10/563,660

Office Action Summary	Application No. 10/563,660	Applicant(s) OKUBO, MIWA	
	Examiner John P. Zimmermann	Art Unit 2861

DETAILED ACTION

FIG. 1

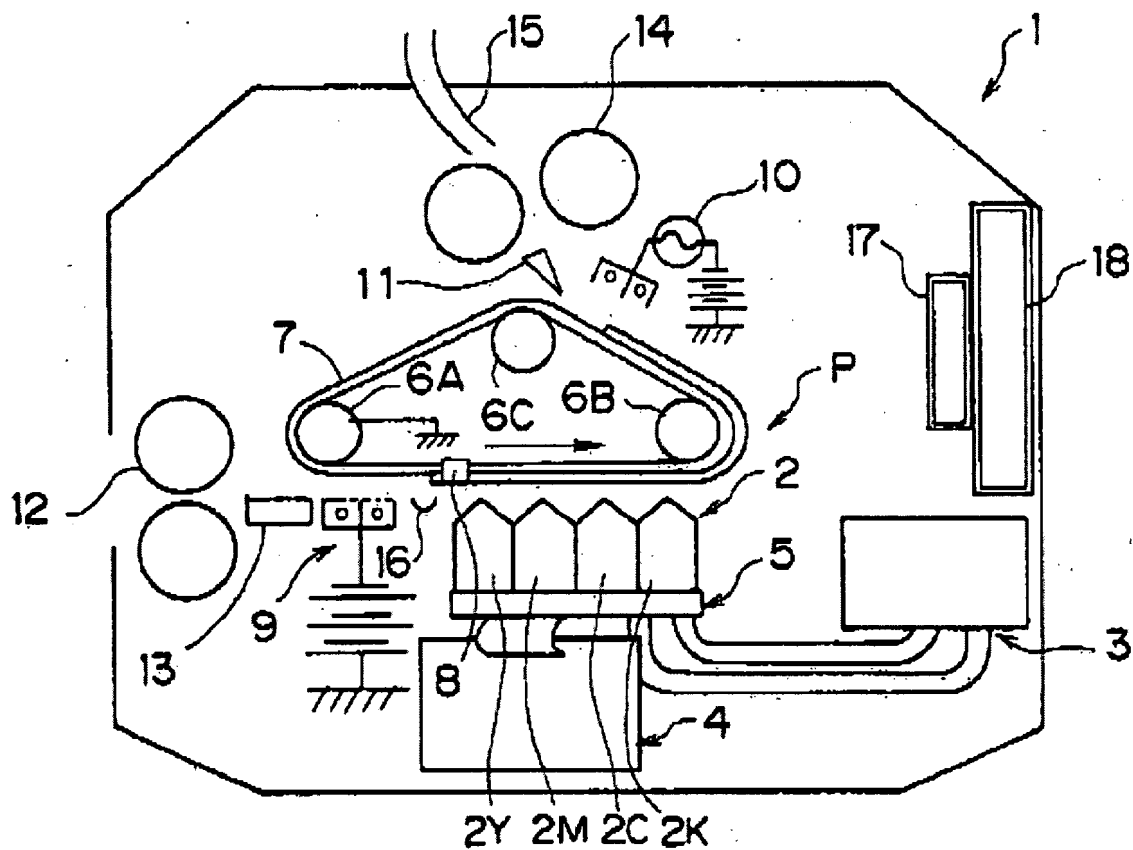
c. As related to independent **claim 4**, Nakazawa et al. teach an ink-jet printer (Nakazawa et al. – Title) in which recording is executed by discharging inks of a plurality

of colors from a discharge opening as droplets of ink to be attached onto a recording material (Nakazawa et al. – Background, Paragraph 5; Summary, Paragraphs 8 & 11; Detailed Description, Paragraph 58 and Figure 1, Reference #2Y, #2M, #2C & #2K, shown below).

d. Continuing with **claim 4**, Nakazawa et al. goes on to teach the case where the interval between a discharge of an ink of a first color and a discharge of an ink of a

second color is 200 mS or less [i.e. 67 μ S] (Nakazawa et al. – Examples, Paragraph 139), inks whose surface tension is 25 to 45 mN/m at 23° C. are used for said inks of each color (Nakazawa et al. – Detailed Description, Paragraphs 118 & 120).
